PRODUCT / PROCESS CHANGE NOTIFICATION

1.1 Company		STMicroelectronics International N.V
1.2 PCN No.		ADG/21/13051
1.3 Title of PCN		STx220N6F7 ,STx140xx (OD68,OD6E): Activation of HHGrace Fab3 (Industrial segment)
1.4 Product Category		see list
1.5 Issue date		2021-10-10

OFT60 Technology (Industrial segment) Activation of Fab3 in HHG

Current flow versus New one

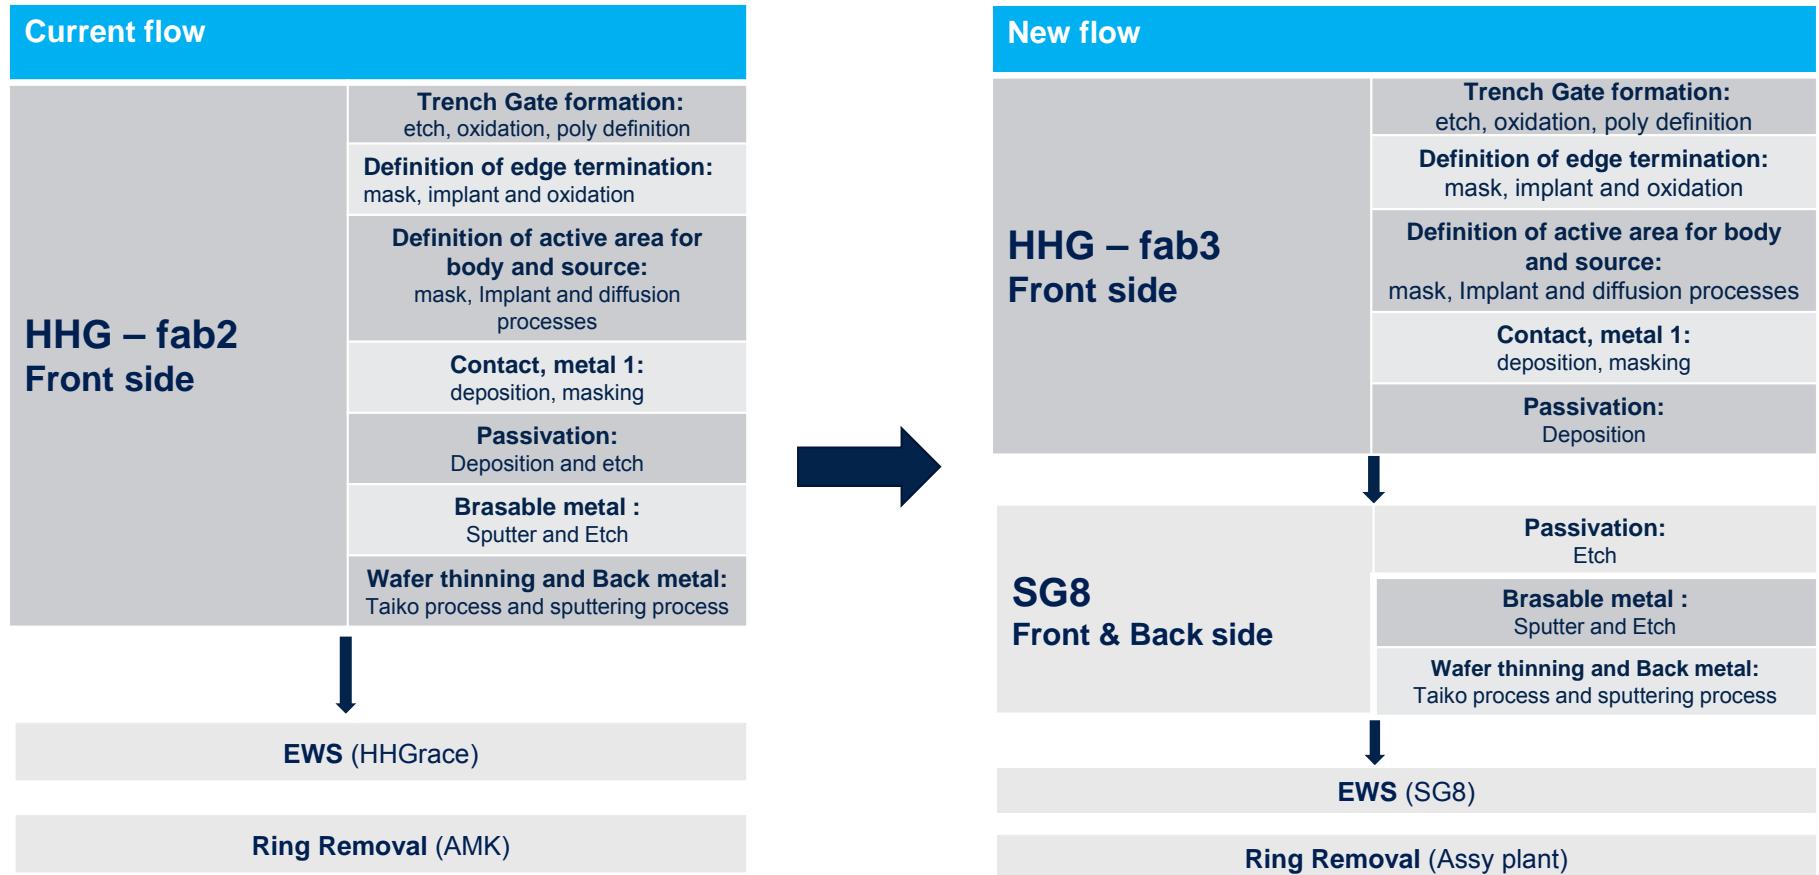
- Qualification activity is on going at HHGrace Fab3 to activate diffusion of OFT60 Technology (Industrial segment)
- The activity is started for some products & lines (described in next slides) and the target is to complete it in Q4'21 with MC30 achievement.
- A change in diffusion flow is introduced with activation of Fab3 and it is described in the next slide. The diffusion process flow performed in Fab3 is the same of Fab2
- No change in product characteristics

* For products where Brasable MTL is not present the SG8 flow consists only in WAFER THINNING & BACK METALIZATION
